TITEL: Modifiering av STOL-sats enligt STC SA1371SW

GÄLLER: Modeller 150 och 152 enligt bifogad kopia av FAA AD 96-12-23 med modifiering enligt STC SA1371SW

LFS: 1996:49

96-12-23 THE CESSNA AIRCRAFT COMPANY: Amendment 39-9666; Docket No. 95-CE-14-AD.

FIGURE 1
MID-AMERICA DWG NO. 1001
(STC SA1371\$W)

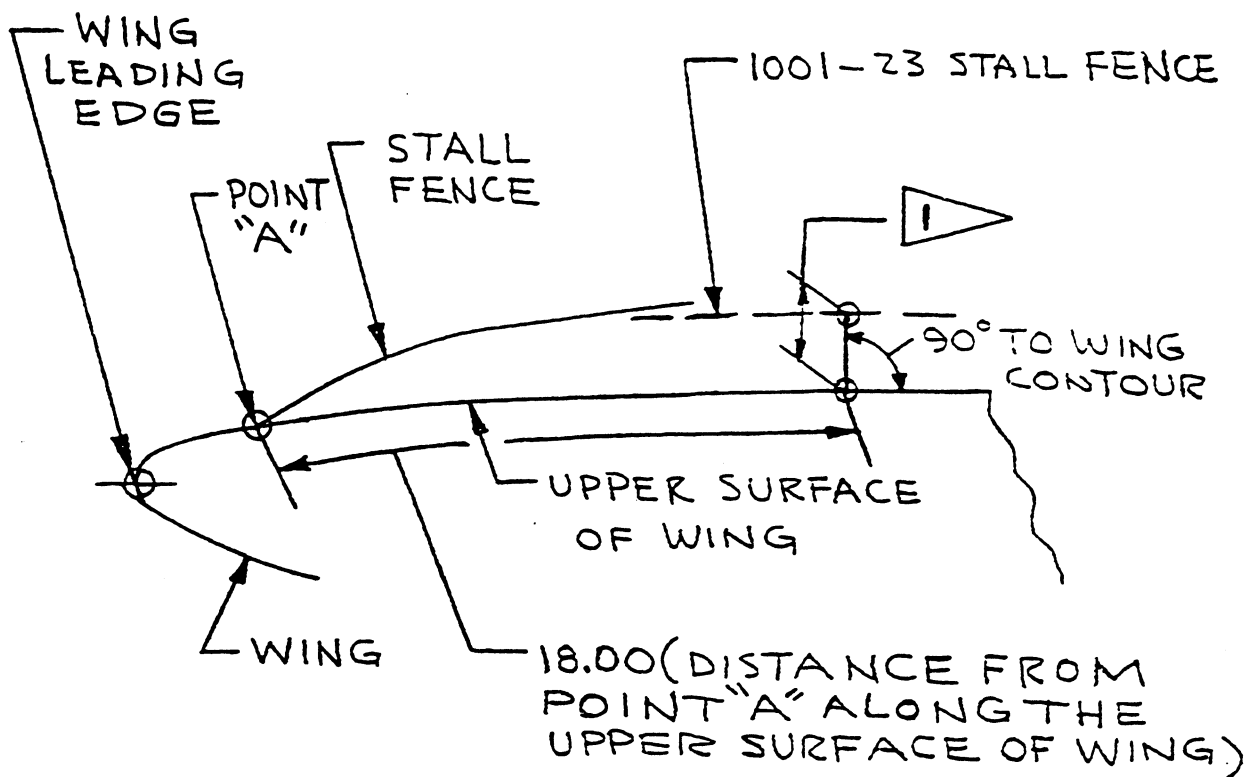
(a) Measure the height of the wing stall fence at its trailing edge to ensure that the height does not exceed 1.28 inches. (See Figure 1 of this AD).

1 IF STALL FENCE IS $1.16 \pm .12$ HIGH THAT IS CORRECT HEIGHT FOR CESSNA 150/152. IF GREATER THAN 1.28 HIGH REMOVE STALL FENCES AND INSTALL THE CORRECT ONE.

(b) If the wing stall fence height exceeds 1.28 inches, prior to further flight, install a smaller fence in accordance with instructions obtained from the Wichita Aircraft Certification Office (ACO), FAA, 1801 Airport Road, Mid-Continent Airport, Wichita, Kansas 67209.
